## MODIFICATION REQUEST: Googong Township Water Cycle Project (MP 08\_0236)

Director-General's  
Environmental Assessment Report  
Section 75W of the  
*Environmental Planning and Assessment Act 1979*

April 2013

**Figure 3:** Modified Water Recycling Plant layout (Source: Googong Township Water Cycle Project Modification Assessment, February 2013)

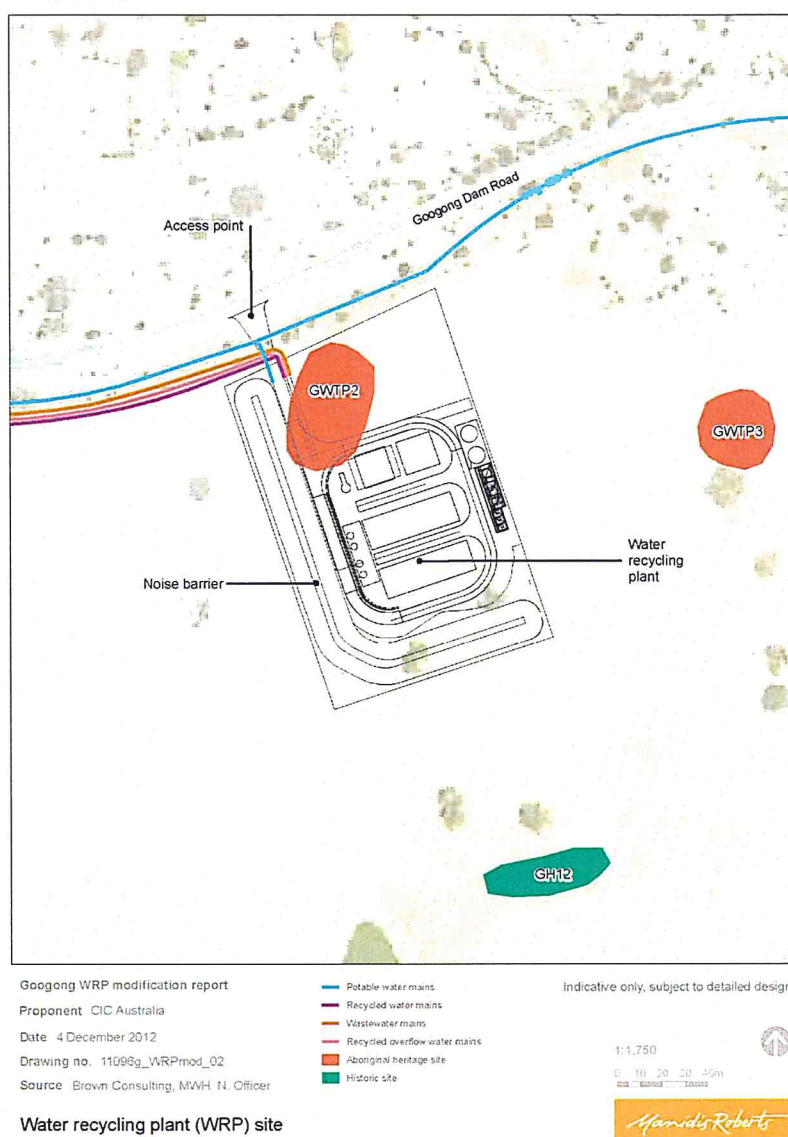
The concept design of the water recycling plant (WRP) consisted of four individual reactors joined into two larger reactors. Detailed design of the WRP has found that separate maintenance access to each reactor and between the reactors is required and this design would require a larger footprint than was anticipated in the EA. No technical or operational changes to the reactors or WRP are required by this proposed change.

The revised layout encroaches upon an Aboriginal heritage item (an artefact scatter identified as GWTP2), identified in the EA and for which no impact was expected.

Condition of Approval C4 provides that “*The Proponent shall not impact items of Aboriginal or non-Indigenous heritage significance identified in the EA*”. The revised WRP layout and footprint will impact on item GWTP2 and will therefore not be consistent with this condition. The modification application therefore proposes to modify Condition C4.

"The Proponent ***shall*** salvage, through surface collection, identified artefacts at site GWTP2 prior to the commencement of construction at that site. Salvage should be carried out in accordance with ***salvage methods described in Navin Officer Heritage Consultants Pty Ltd, October 2012 "Methodology: Googong Township Truck Water Main and Recycled Water System". Salvaged artefacts should be relocated in accordance with the artefact relocation methods as described in Navin Officer Heritage Consultants Pty Ltd (24 June 2010) "Back to Country Proposal to Reposition Salvaged Aboriginal Artefacts from the Googong New Town (Neighbourhood 1A) Development*** ~~the methodology developed in consultation with OEH and registered Aboriginal parties.~~ The Proponent shall not impact any other item of Aboriginal or non-Indigenous heritage significance identified in the EA".
